## Notice: Development of Improved SF72 Series nano SIM Card Connector

Current	Part Number	SJ No.
Current Product	SF72S006VBAR2500	SJ114536
Improved Product	SF72S006VBDR2500	SJ117562

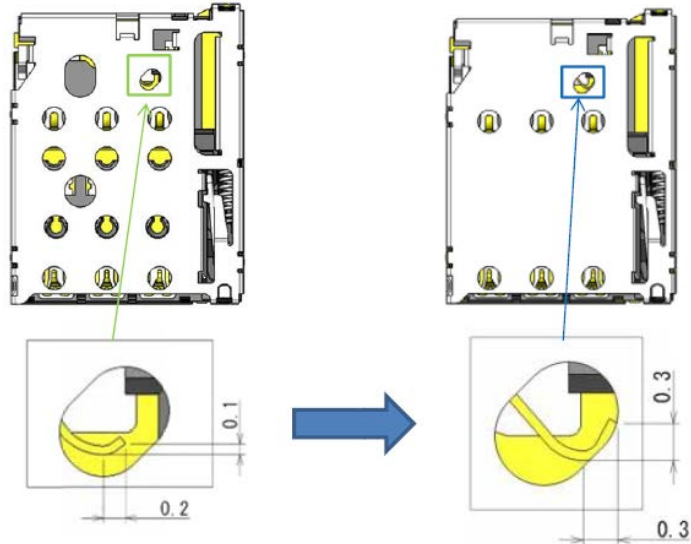
1. Reduce number of holes on cover → Expand vacuum pick-up area

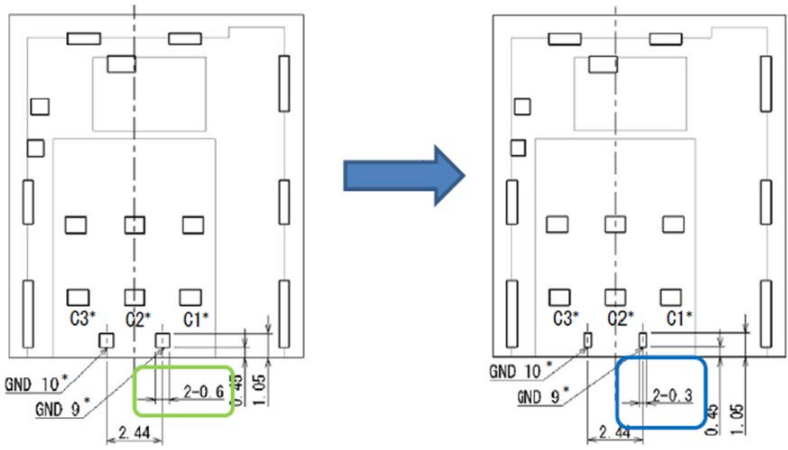
**3. Changed dimension of 2 pads on PCB footprint → Reduces risk of excess solder being applied**

Applicable PCB Dimension  
Foot Pattern Width: 0.6mm  
SF72S006VBA

Applicable PCB Dimension  
Foot Pattern Width: 0.3mm  
SF72S006VBD
